Contract #: 04-0120F4Cty: SF/ALA Rte: 80 PM: 13.2/13.9File #: 69.25B**QUALITY ASSURANCE -- NON-CONFORMANCE REPORT****Location:** Changxing Island, Shanghai, P.R. China**Report No:** NCR-000851**Prime Contractor:** American Bridge/Fluor Enterprises, a JV**Date:** 27-Sep-2010**Submitting Contractor:** Zhenhua Port Machinery Company, Ltd (ZPMC), Changxing Island**NCR #:** ZPMC-0813**Type of problem:**

Reference Description: Excessive heat was utilized during heat straightening of the top anchorage plate stiffener

Subject: NCR No. ZPMC-0813

Contract #: 04-0120F4Cty: SF/ALA Rte: 80 PM: 13.2/13.9File #: xx.25A**QUALITY ASSURANCE -- NON-CONFORMANCE RESOLUTION****Location:** Changxing Island, Shanghai, P.R. China**Report No:** NCS-000777**Prime Contractor:** American Bridge/Fluor Enterprises, a JV**Date:** 13-Oct-2010**Submitting Contractor:** Zhenhua Port Machinery Company, Ltd (ZPMC), Changxing Island **NCR #:** ZPMC-0813**Type of problem:**

Welding	Concrete	Other	
Welding	Curing	Procedural	Bridge No: 34-0006
Joint fit-up	Coating	Other	Component: Lift 14 Top Anchorage Plate Stiffener
Procedural	Procedural	Description:

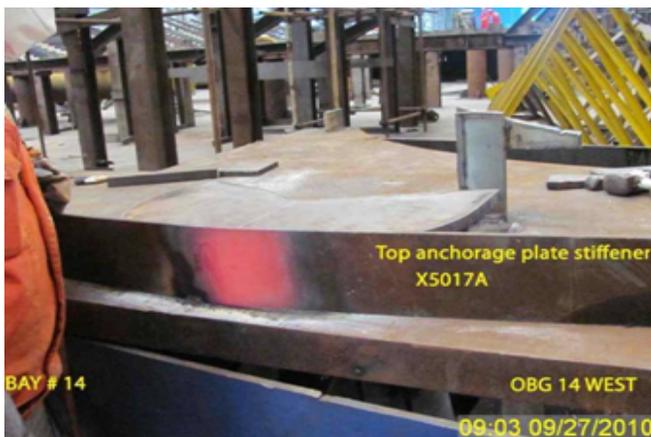
- ZPMC personnel performing hot bending on the top anchorage plate stiffener identified as X5017A.
- This QA Inspector observed the 1100°C Tempstick was melted when struck against the red base metal.
- The material was heated to a bright red condition and the temperature is above 1100°C.
- Thickness of the stiffener measured 14mm.
- This stiffener in OBG Fabrication Bay #14.

AWS D1.5 2002; 3.7.3 - Members distorted by welding shall be straightened by mechanical means or by carefully supervised application of a limited amount of localized heat as approved by the Engineer. The temperature of the heated areas as measured by approved methods shall not exceed 600C for quenched and

tempered steel nor 650C for other steels.

If a radius shorter than the minimum specified for cold-bending is essential, the plates shall be bent hot at a temperature not greater than 1200°F (650°C).

Reference Resolution: ZPMC acknowledges that this piece was overheated. This piece has been rejected by ZPMC and will not be used.

Contractor rejected the material and will re-fabricate a new piece. This NCR is closed.

Component: Lift 14 Top Anchorage Plate Stiffener

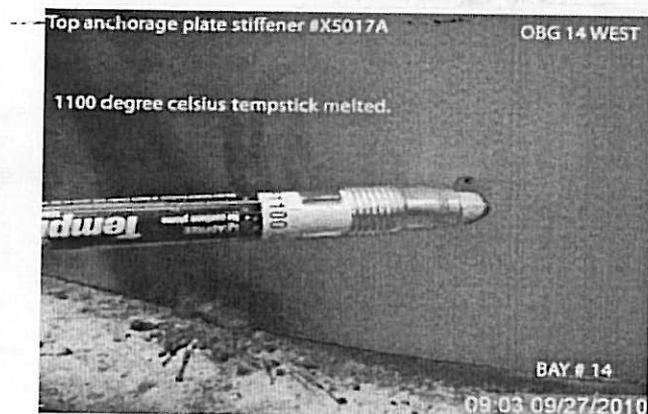
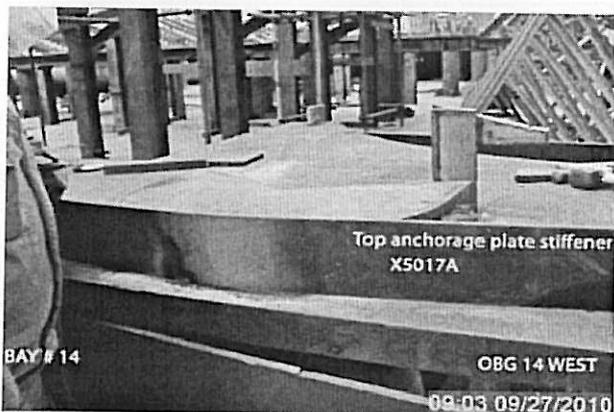
- ZPMC personnel performing hot bending on the top anchorage plate stiffener identified as X5017A.
- This QA Inspector observed the 1100°C Tempstick was melted when struck against the red base metal.
- The material was heated to a bright red condition and the temperature is above 1100°C.
- Thickness of the stiffener measured 14mm.
- This stiffener in OBG Fabrication Bay #14.

AWS D1.5 2002; 3.7.3 - Members distorted by welding shall be straightened by mechanical means or by carefully supervised application of a limited amount of localized heat as approved by the Engineer. The temperature of the heated areas as measured by approved methods shall not exceed 600C for quenched and

tempered steel nor 650C for other steels.

If a radius shorter than the minimum specified for cold-bending is essential, the plates shall be bent hot at a temperature not greater than 1200°F (650°C).

"ZPMC acknowledges that this piece was overheated. This piece has been rejected by ZPMC and will not be used. The work crew who performed the overheating will be fined in order to pay for the overheated stiffener. This financial penalty will be a deterrent to these workers and others performing overheating. After heating, ZPMC performed NDT and is providing the result to show the material is acceptable."

Reject the material and re-fabricate a new piece.
